Attachment 3 to Initial Comments of the Clean Energy Organizations

**RE: Comments of National Parks Conservation Association and
Sierra Club on the Draft North Dakota State Implementation Plan
for Regional Haze for the Second Planning Period.**

National Parks Conservation Association (“NPCA”) and Sierra Club, and Badlands Conservation Alliance (“Conservation Organizations”) submit the attached comments on North Dakota Department of Environmental Quality’s (“DEQ’s”) Draft State Implementation Plan (“SIP”) for Regional Haze for the Second Planning Period. We also attach and incorporate by reference the following technical comments regarding North Dakota’s second planning period SIP: (1) A Review of North Dakota Regional Haze State Implementation Plan, prepared by Joe Kordzi, dated May 2022 (attached as Ex. 1) [“2022 Kordzi Report”]; (2) *A Review of the Record Concerning the Technical Feasibility of Selective Catalytic Reduction on North Dakota Lignite Electric Generating Units*, prepared by Joe Kordzi and Ron Sahu, dated October 2020 (attached as Ex. 2) [“SCR Technical Feasibility Report”]; (3) *NO_x and SO₂ Reasonable Progress Analysis for the Otter Tail Coyote Station*, prepared

Figure 1. Coyote Unit 1 30 BOD SO₂ Emissions

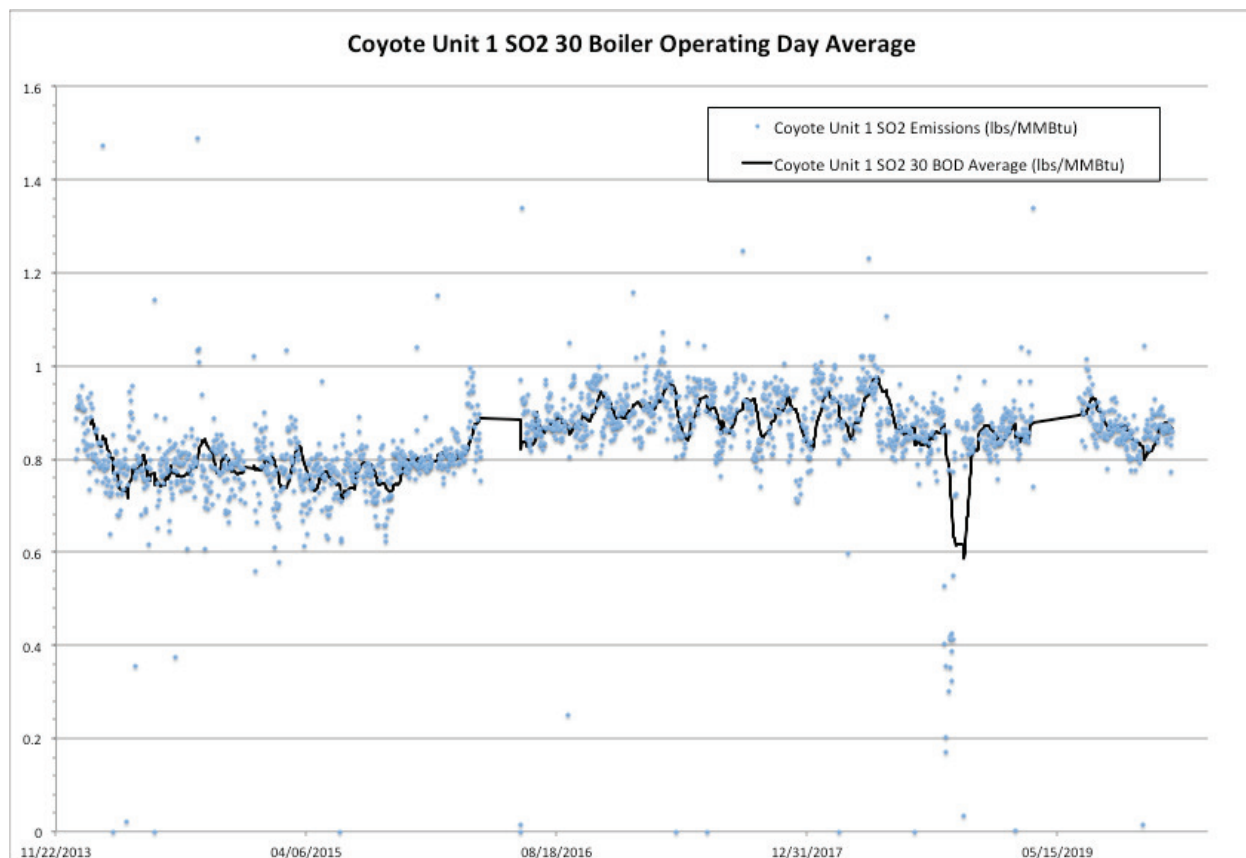
information on this test, so that it can be properly evaluated. It appears from an examination of Coyote's 24 hour SO₂ emissions that even lower emissions were actually achieved, as the following figure demonstrates:

As can be seen from examining the 24 hour emissions in Figure 4, the daily SO₂ emissions during this test (the dip in the right portion of the graph) much lower than 0.50 lbs/MMBtu were achieved.⁵

Figure 6. Henry Hub Monthly Natural Gas Spot Price.

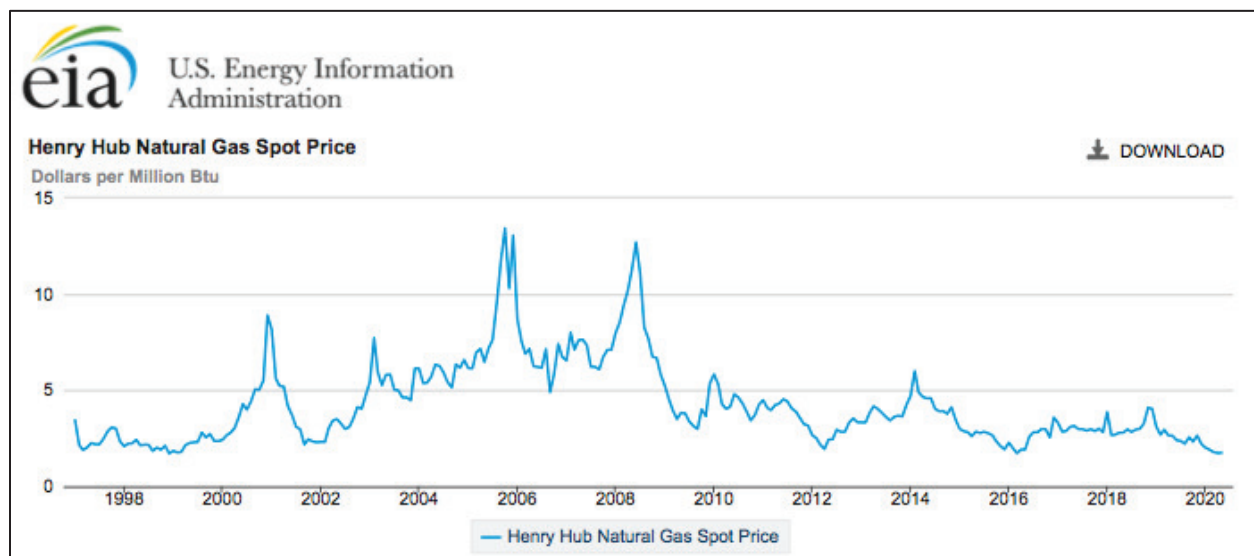
Dr. Fox criticized S&L for inflating the cost of natural gas for use in the reheaters. She noted that S&L assumed a cost ranging on \$8/MMBtu to \$12/MMBtu was, based on the Henry Hub spot price market, more reasonably estimated at \$5.5/MMBtu, which included a transportation cost of \$1/MMBtu. As the following chart from the Energy Information Agency indicates, her adjustment was correct:⁴⁸

Regarding future predictions, the EIA states, “The June STEO expects higher natural gas prices by the end of 2020, forecasting Henry Hub to average \$2.95/MMBtu in December.”⁴⁹ Adding in the same \$1/MMBtu transportation cost results in a currently reasonable natural gas price of approximately \$4/MMBtu, in contrast to the \$5.50/MMBtu used in Dr. Fox’s cost analysis. Consequently, I will adjust the price of natural gas to \$4/MMBtu.

Figure 7. Coyote Monthly NO_x emissions

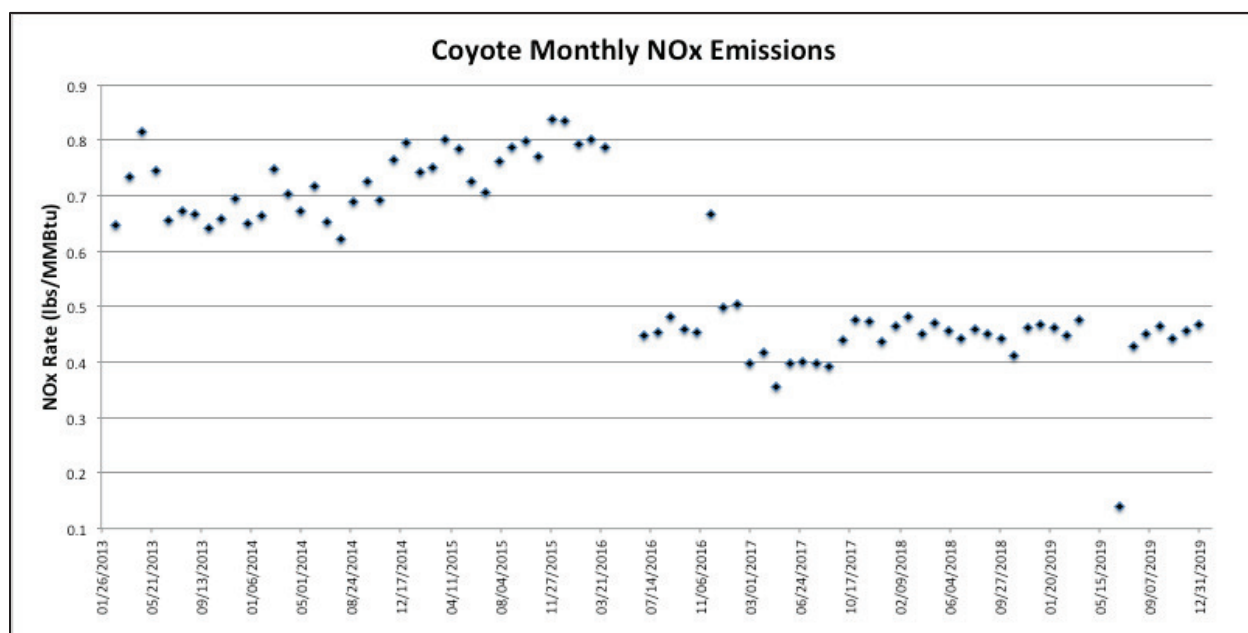
The cost analysis methodology used by S&L for Leland Olds and adopted by Dr. Fox calculates the amount of NO_x removed based on the difference between the NO_x rate baseline and the SCR NO_x outlet. Dr. Fox adopted S&L's NO_x rate baseline of 0.48 lbs/MMBtu for Leland Olds. This should be re-examined for Coyote. Below are the monthly NO_x emissions from Coyote:⁶²

As discussed above, this analysis considers the time after June 15, 2016, when Coyote's SOFA was installed. Each data point depicted in Figure 2 represents one month's NO_x average. I note that in its May 8, 2019 Coyote four-factor analysis, Otter Tail indicates the Coyote NO_x baseline emission rate is 0.46 lbs/MMBtu.⁶³ It therefore appears to me this is a reasonable NO_x baseline and I will use it in my Coyote analysis. Therefore, using the same SCR outlet of 0.05 lbs/MMBtu adopted by Dr. Fox in her Leland Olds cost analysis, a SCR control efficiency of 89.1% is calculated: $100\% \times (1 - (0.05/0.46)) = 89.1\%$. The annual tonnage of NO_x removed is then 6,393.⁶⁴
